SUBJECT: Forwards response to NRC 800223 ltr re LWR primary coolant sys pressure isolation valves. Instrumentation is provided to monitor pressure of low pressure side of Check Valves V-3217, V-3227, V-3237 & V-3247. Flow diagram encl.

March 17, 1980
L-80-85

Re: ST. LUCIE UNIT 1
DOCKET NO. 50-335
RCS PRESSURE ISOLATION

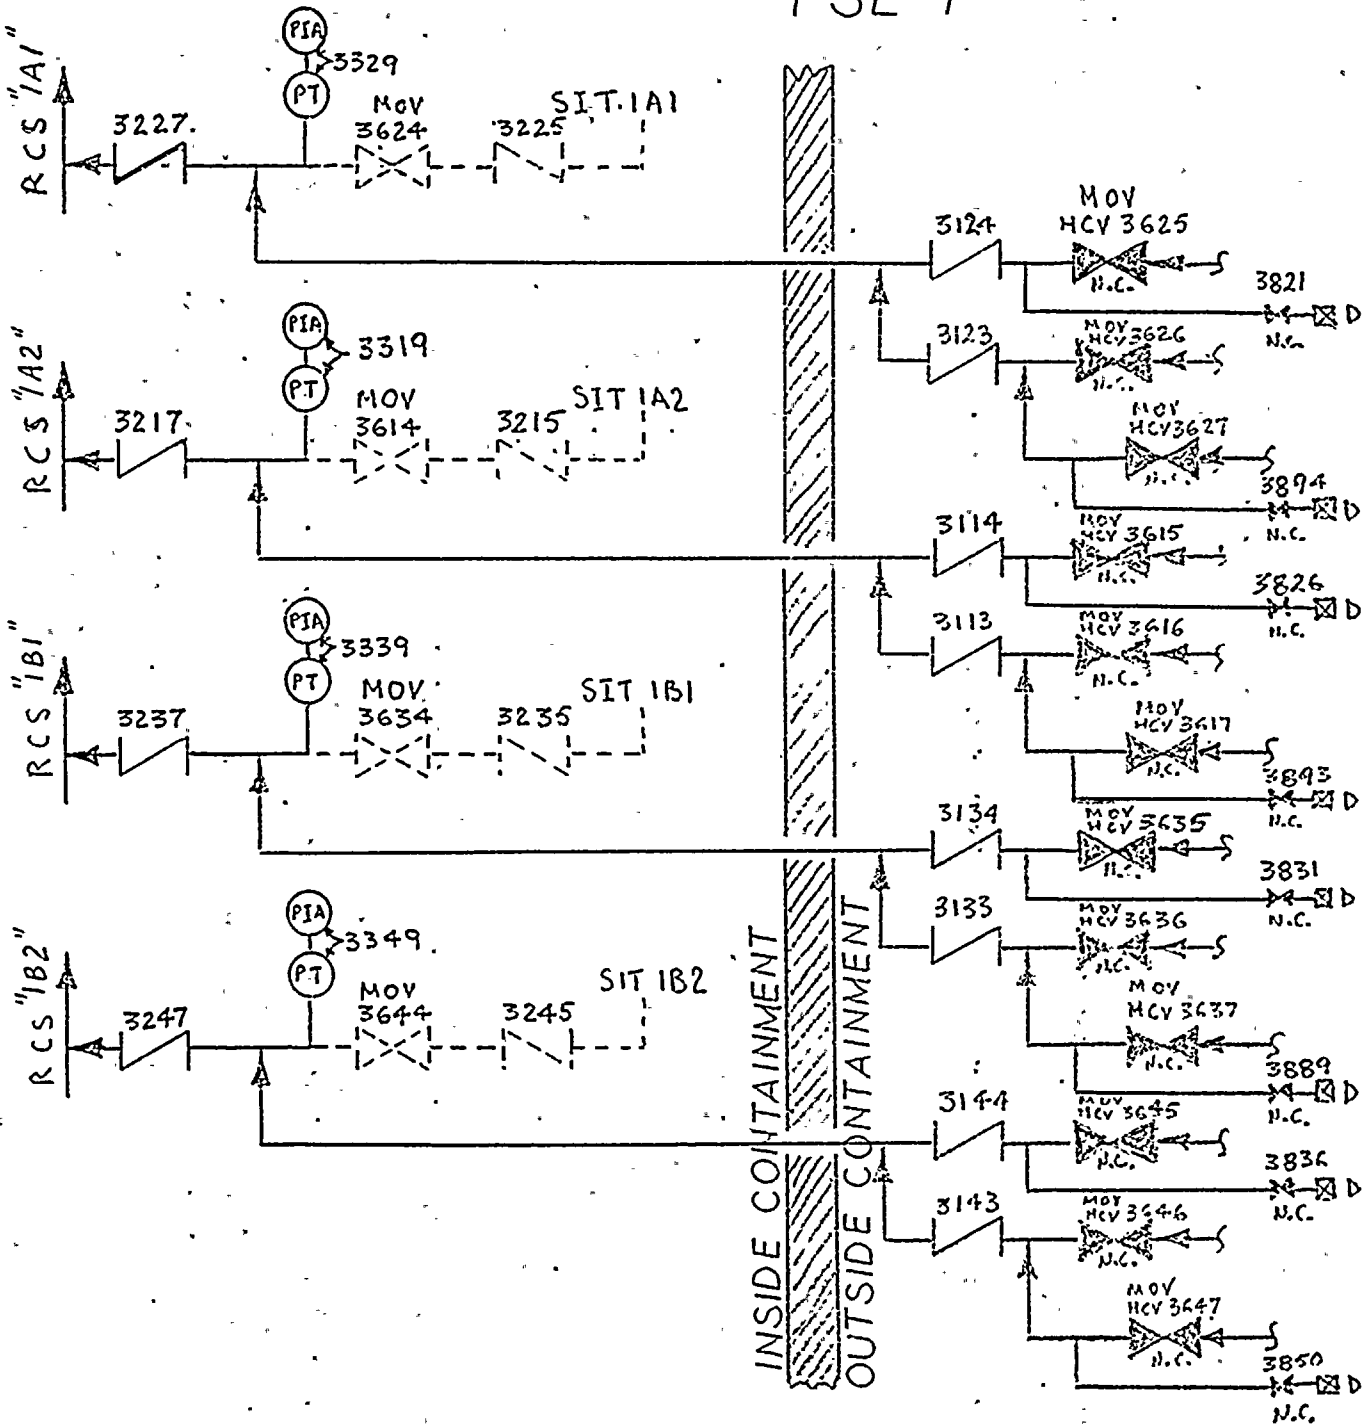
Describe the valve configuration at your plant and indicate if an Event V isolation valve configuration exists within the Class I boundary of the high pressure piping connecting PCS (Primary Coolant System) piping to low pressure system piping; e.g., (1) two check valves in series, or (2) two check valves in series with a MOV.

If either of the above Event V configurations exist at your facility, indicate whether continuous surveillance or periodic tests are being accomplished on such valves to ensure integrity. Also indicate whether valves have been known, or found, to lack integrity.

If either of the above Event V configurations exist at your facility, indicate whether plant procedures should be revised or if plant modifications should be made to increase reliability.

Attached is a simplified flow diagram showing the isolation valve configurations identified as Event V arrangements for St. Lucie Unit 1.

Instrumentation is provided to monitor the pressure on the low pressure side of check valve nos. V-3217, V-3227, V-3237, & V-3247. An alarm is received in the Control Room when the pressure upstream of the check valves exceeds the alarm set point. No other surveillance tests to assess the integrity of the other check valves identified as Event V arrangements are currently being performed.

Procedures will be reviewed and revised as required to provide for continuous monitoring on the low pressure side of check valve nos. V-3217, V-3227, V-3237, and V-3247 using the installed instrumentation.

Procedures will be revised during the current refueling outage to provide for periodic surveillance testing for check valve nos.:

- V-3113 & V-3114
- V-3123 & V-3124
- V-3133 & V-3134
- V-3143 & V-3144

The tests will be performed to assess check valve integrity following cold shutdown or refueling shutdown.
